# INNER WEST COUNCIL

## DEVELOPMENT ASSESSMENT REPORT

<b>Application No.</b>	10.2017.84.1
<b>Address</b>	10 Arthur Street, Ashfield
<b>Proposal</b>	Alterations and additions to the existing dwelling involving:- <ul style="list-style-type: none"> <li>• two storey rear addition;</li> <li>• attached garage; and</li> <li>• removal of four trees</li> </ul>
<b>Date of Lodgement</b>	30 May 2017
<b>Applicant</b>	Mr W H Ho C/- James Kim
<b>Owner</b>	Ms F X Huang
<b>Number of Submissions</b>	20 submissions
<b>Value of works</b>	\$667,000.00
<b>Reason for determination at Planning Panel</b>	Number of submissions received
<b>Main Issue/s</b>	Privacy – First floor windows
<b>Recommendation</b>	Conditional approval

<p>1 PROPOSED NORTH ELEVATION</p> <p>SCALE 1:50</p> 		<p>2 PROPOSED INTERNAL NORTH ELEVATION</p> <p>SCALE 1:50</p> 		<p>3 PROPOSED SOUTH ELEVATION</p> <p>SCALE 1:50</p>

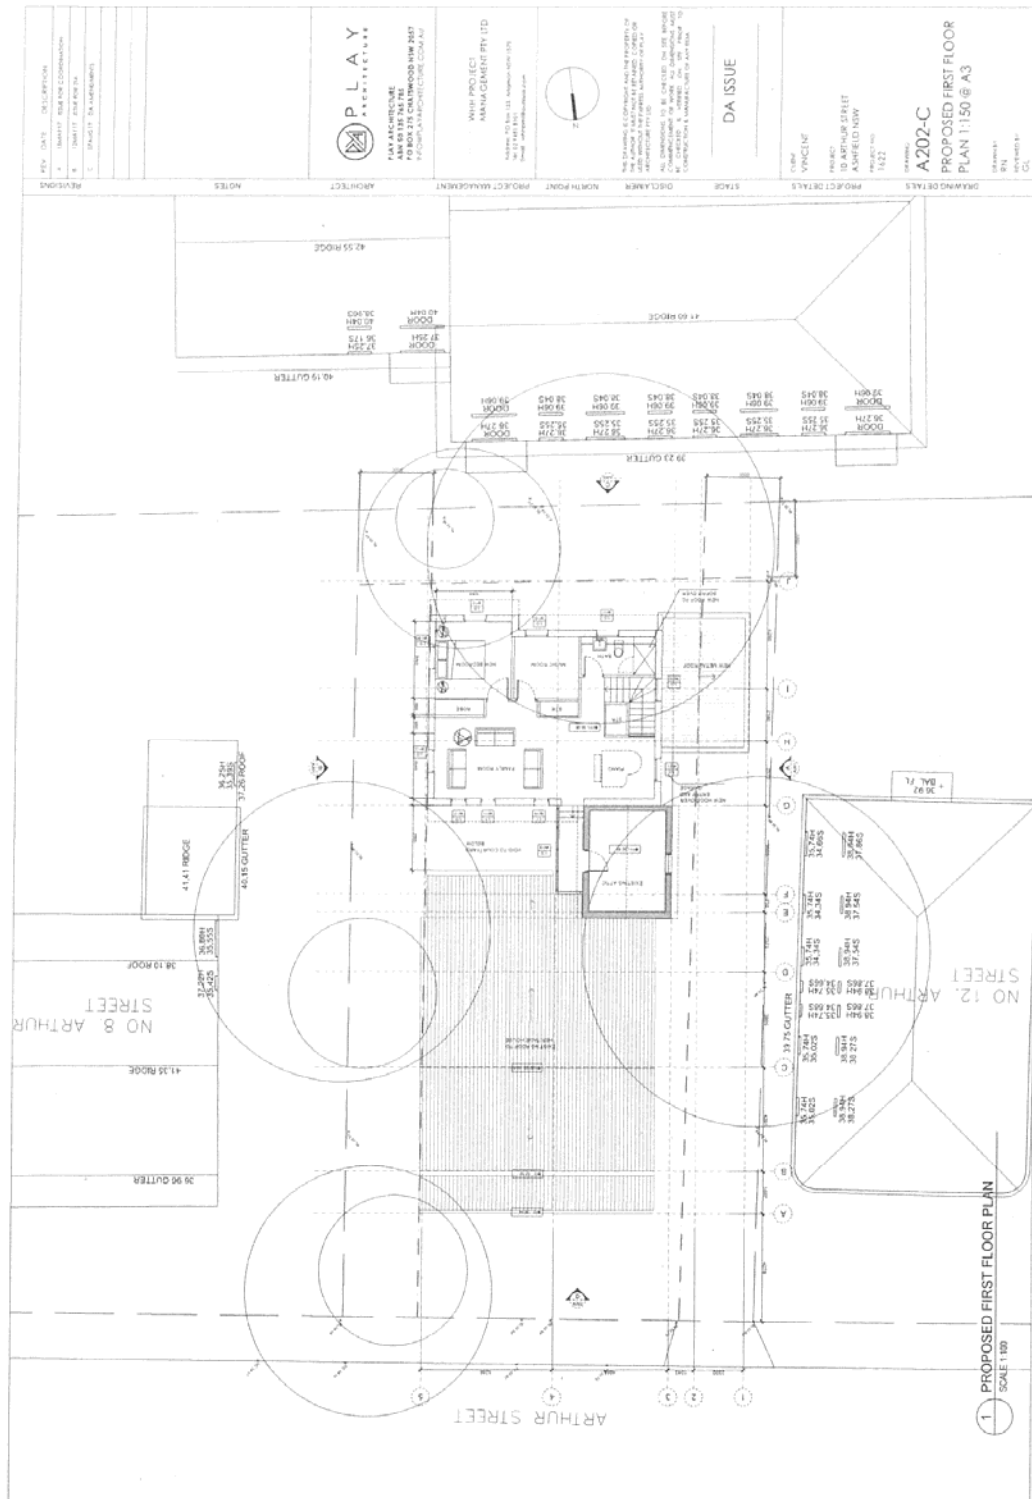
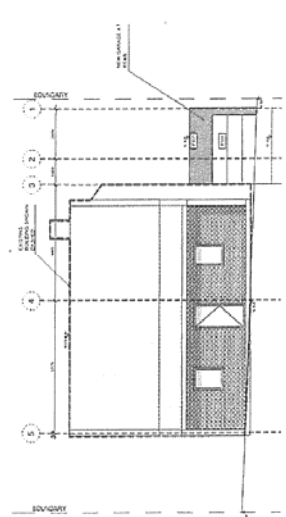
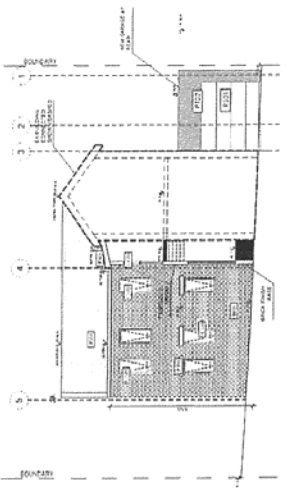
- (a)     The windows marked as filmed on the approved plans shall ensure this film is obscured film.
- (b)     The two upper floor windows in the rear addition on the eastern elevation shall be provided with obscure film.
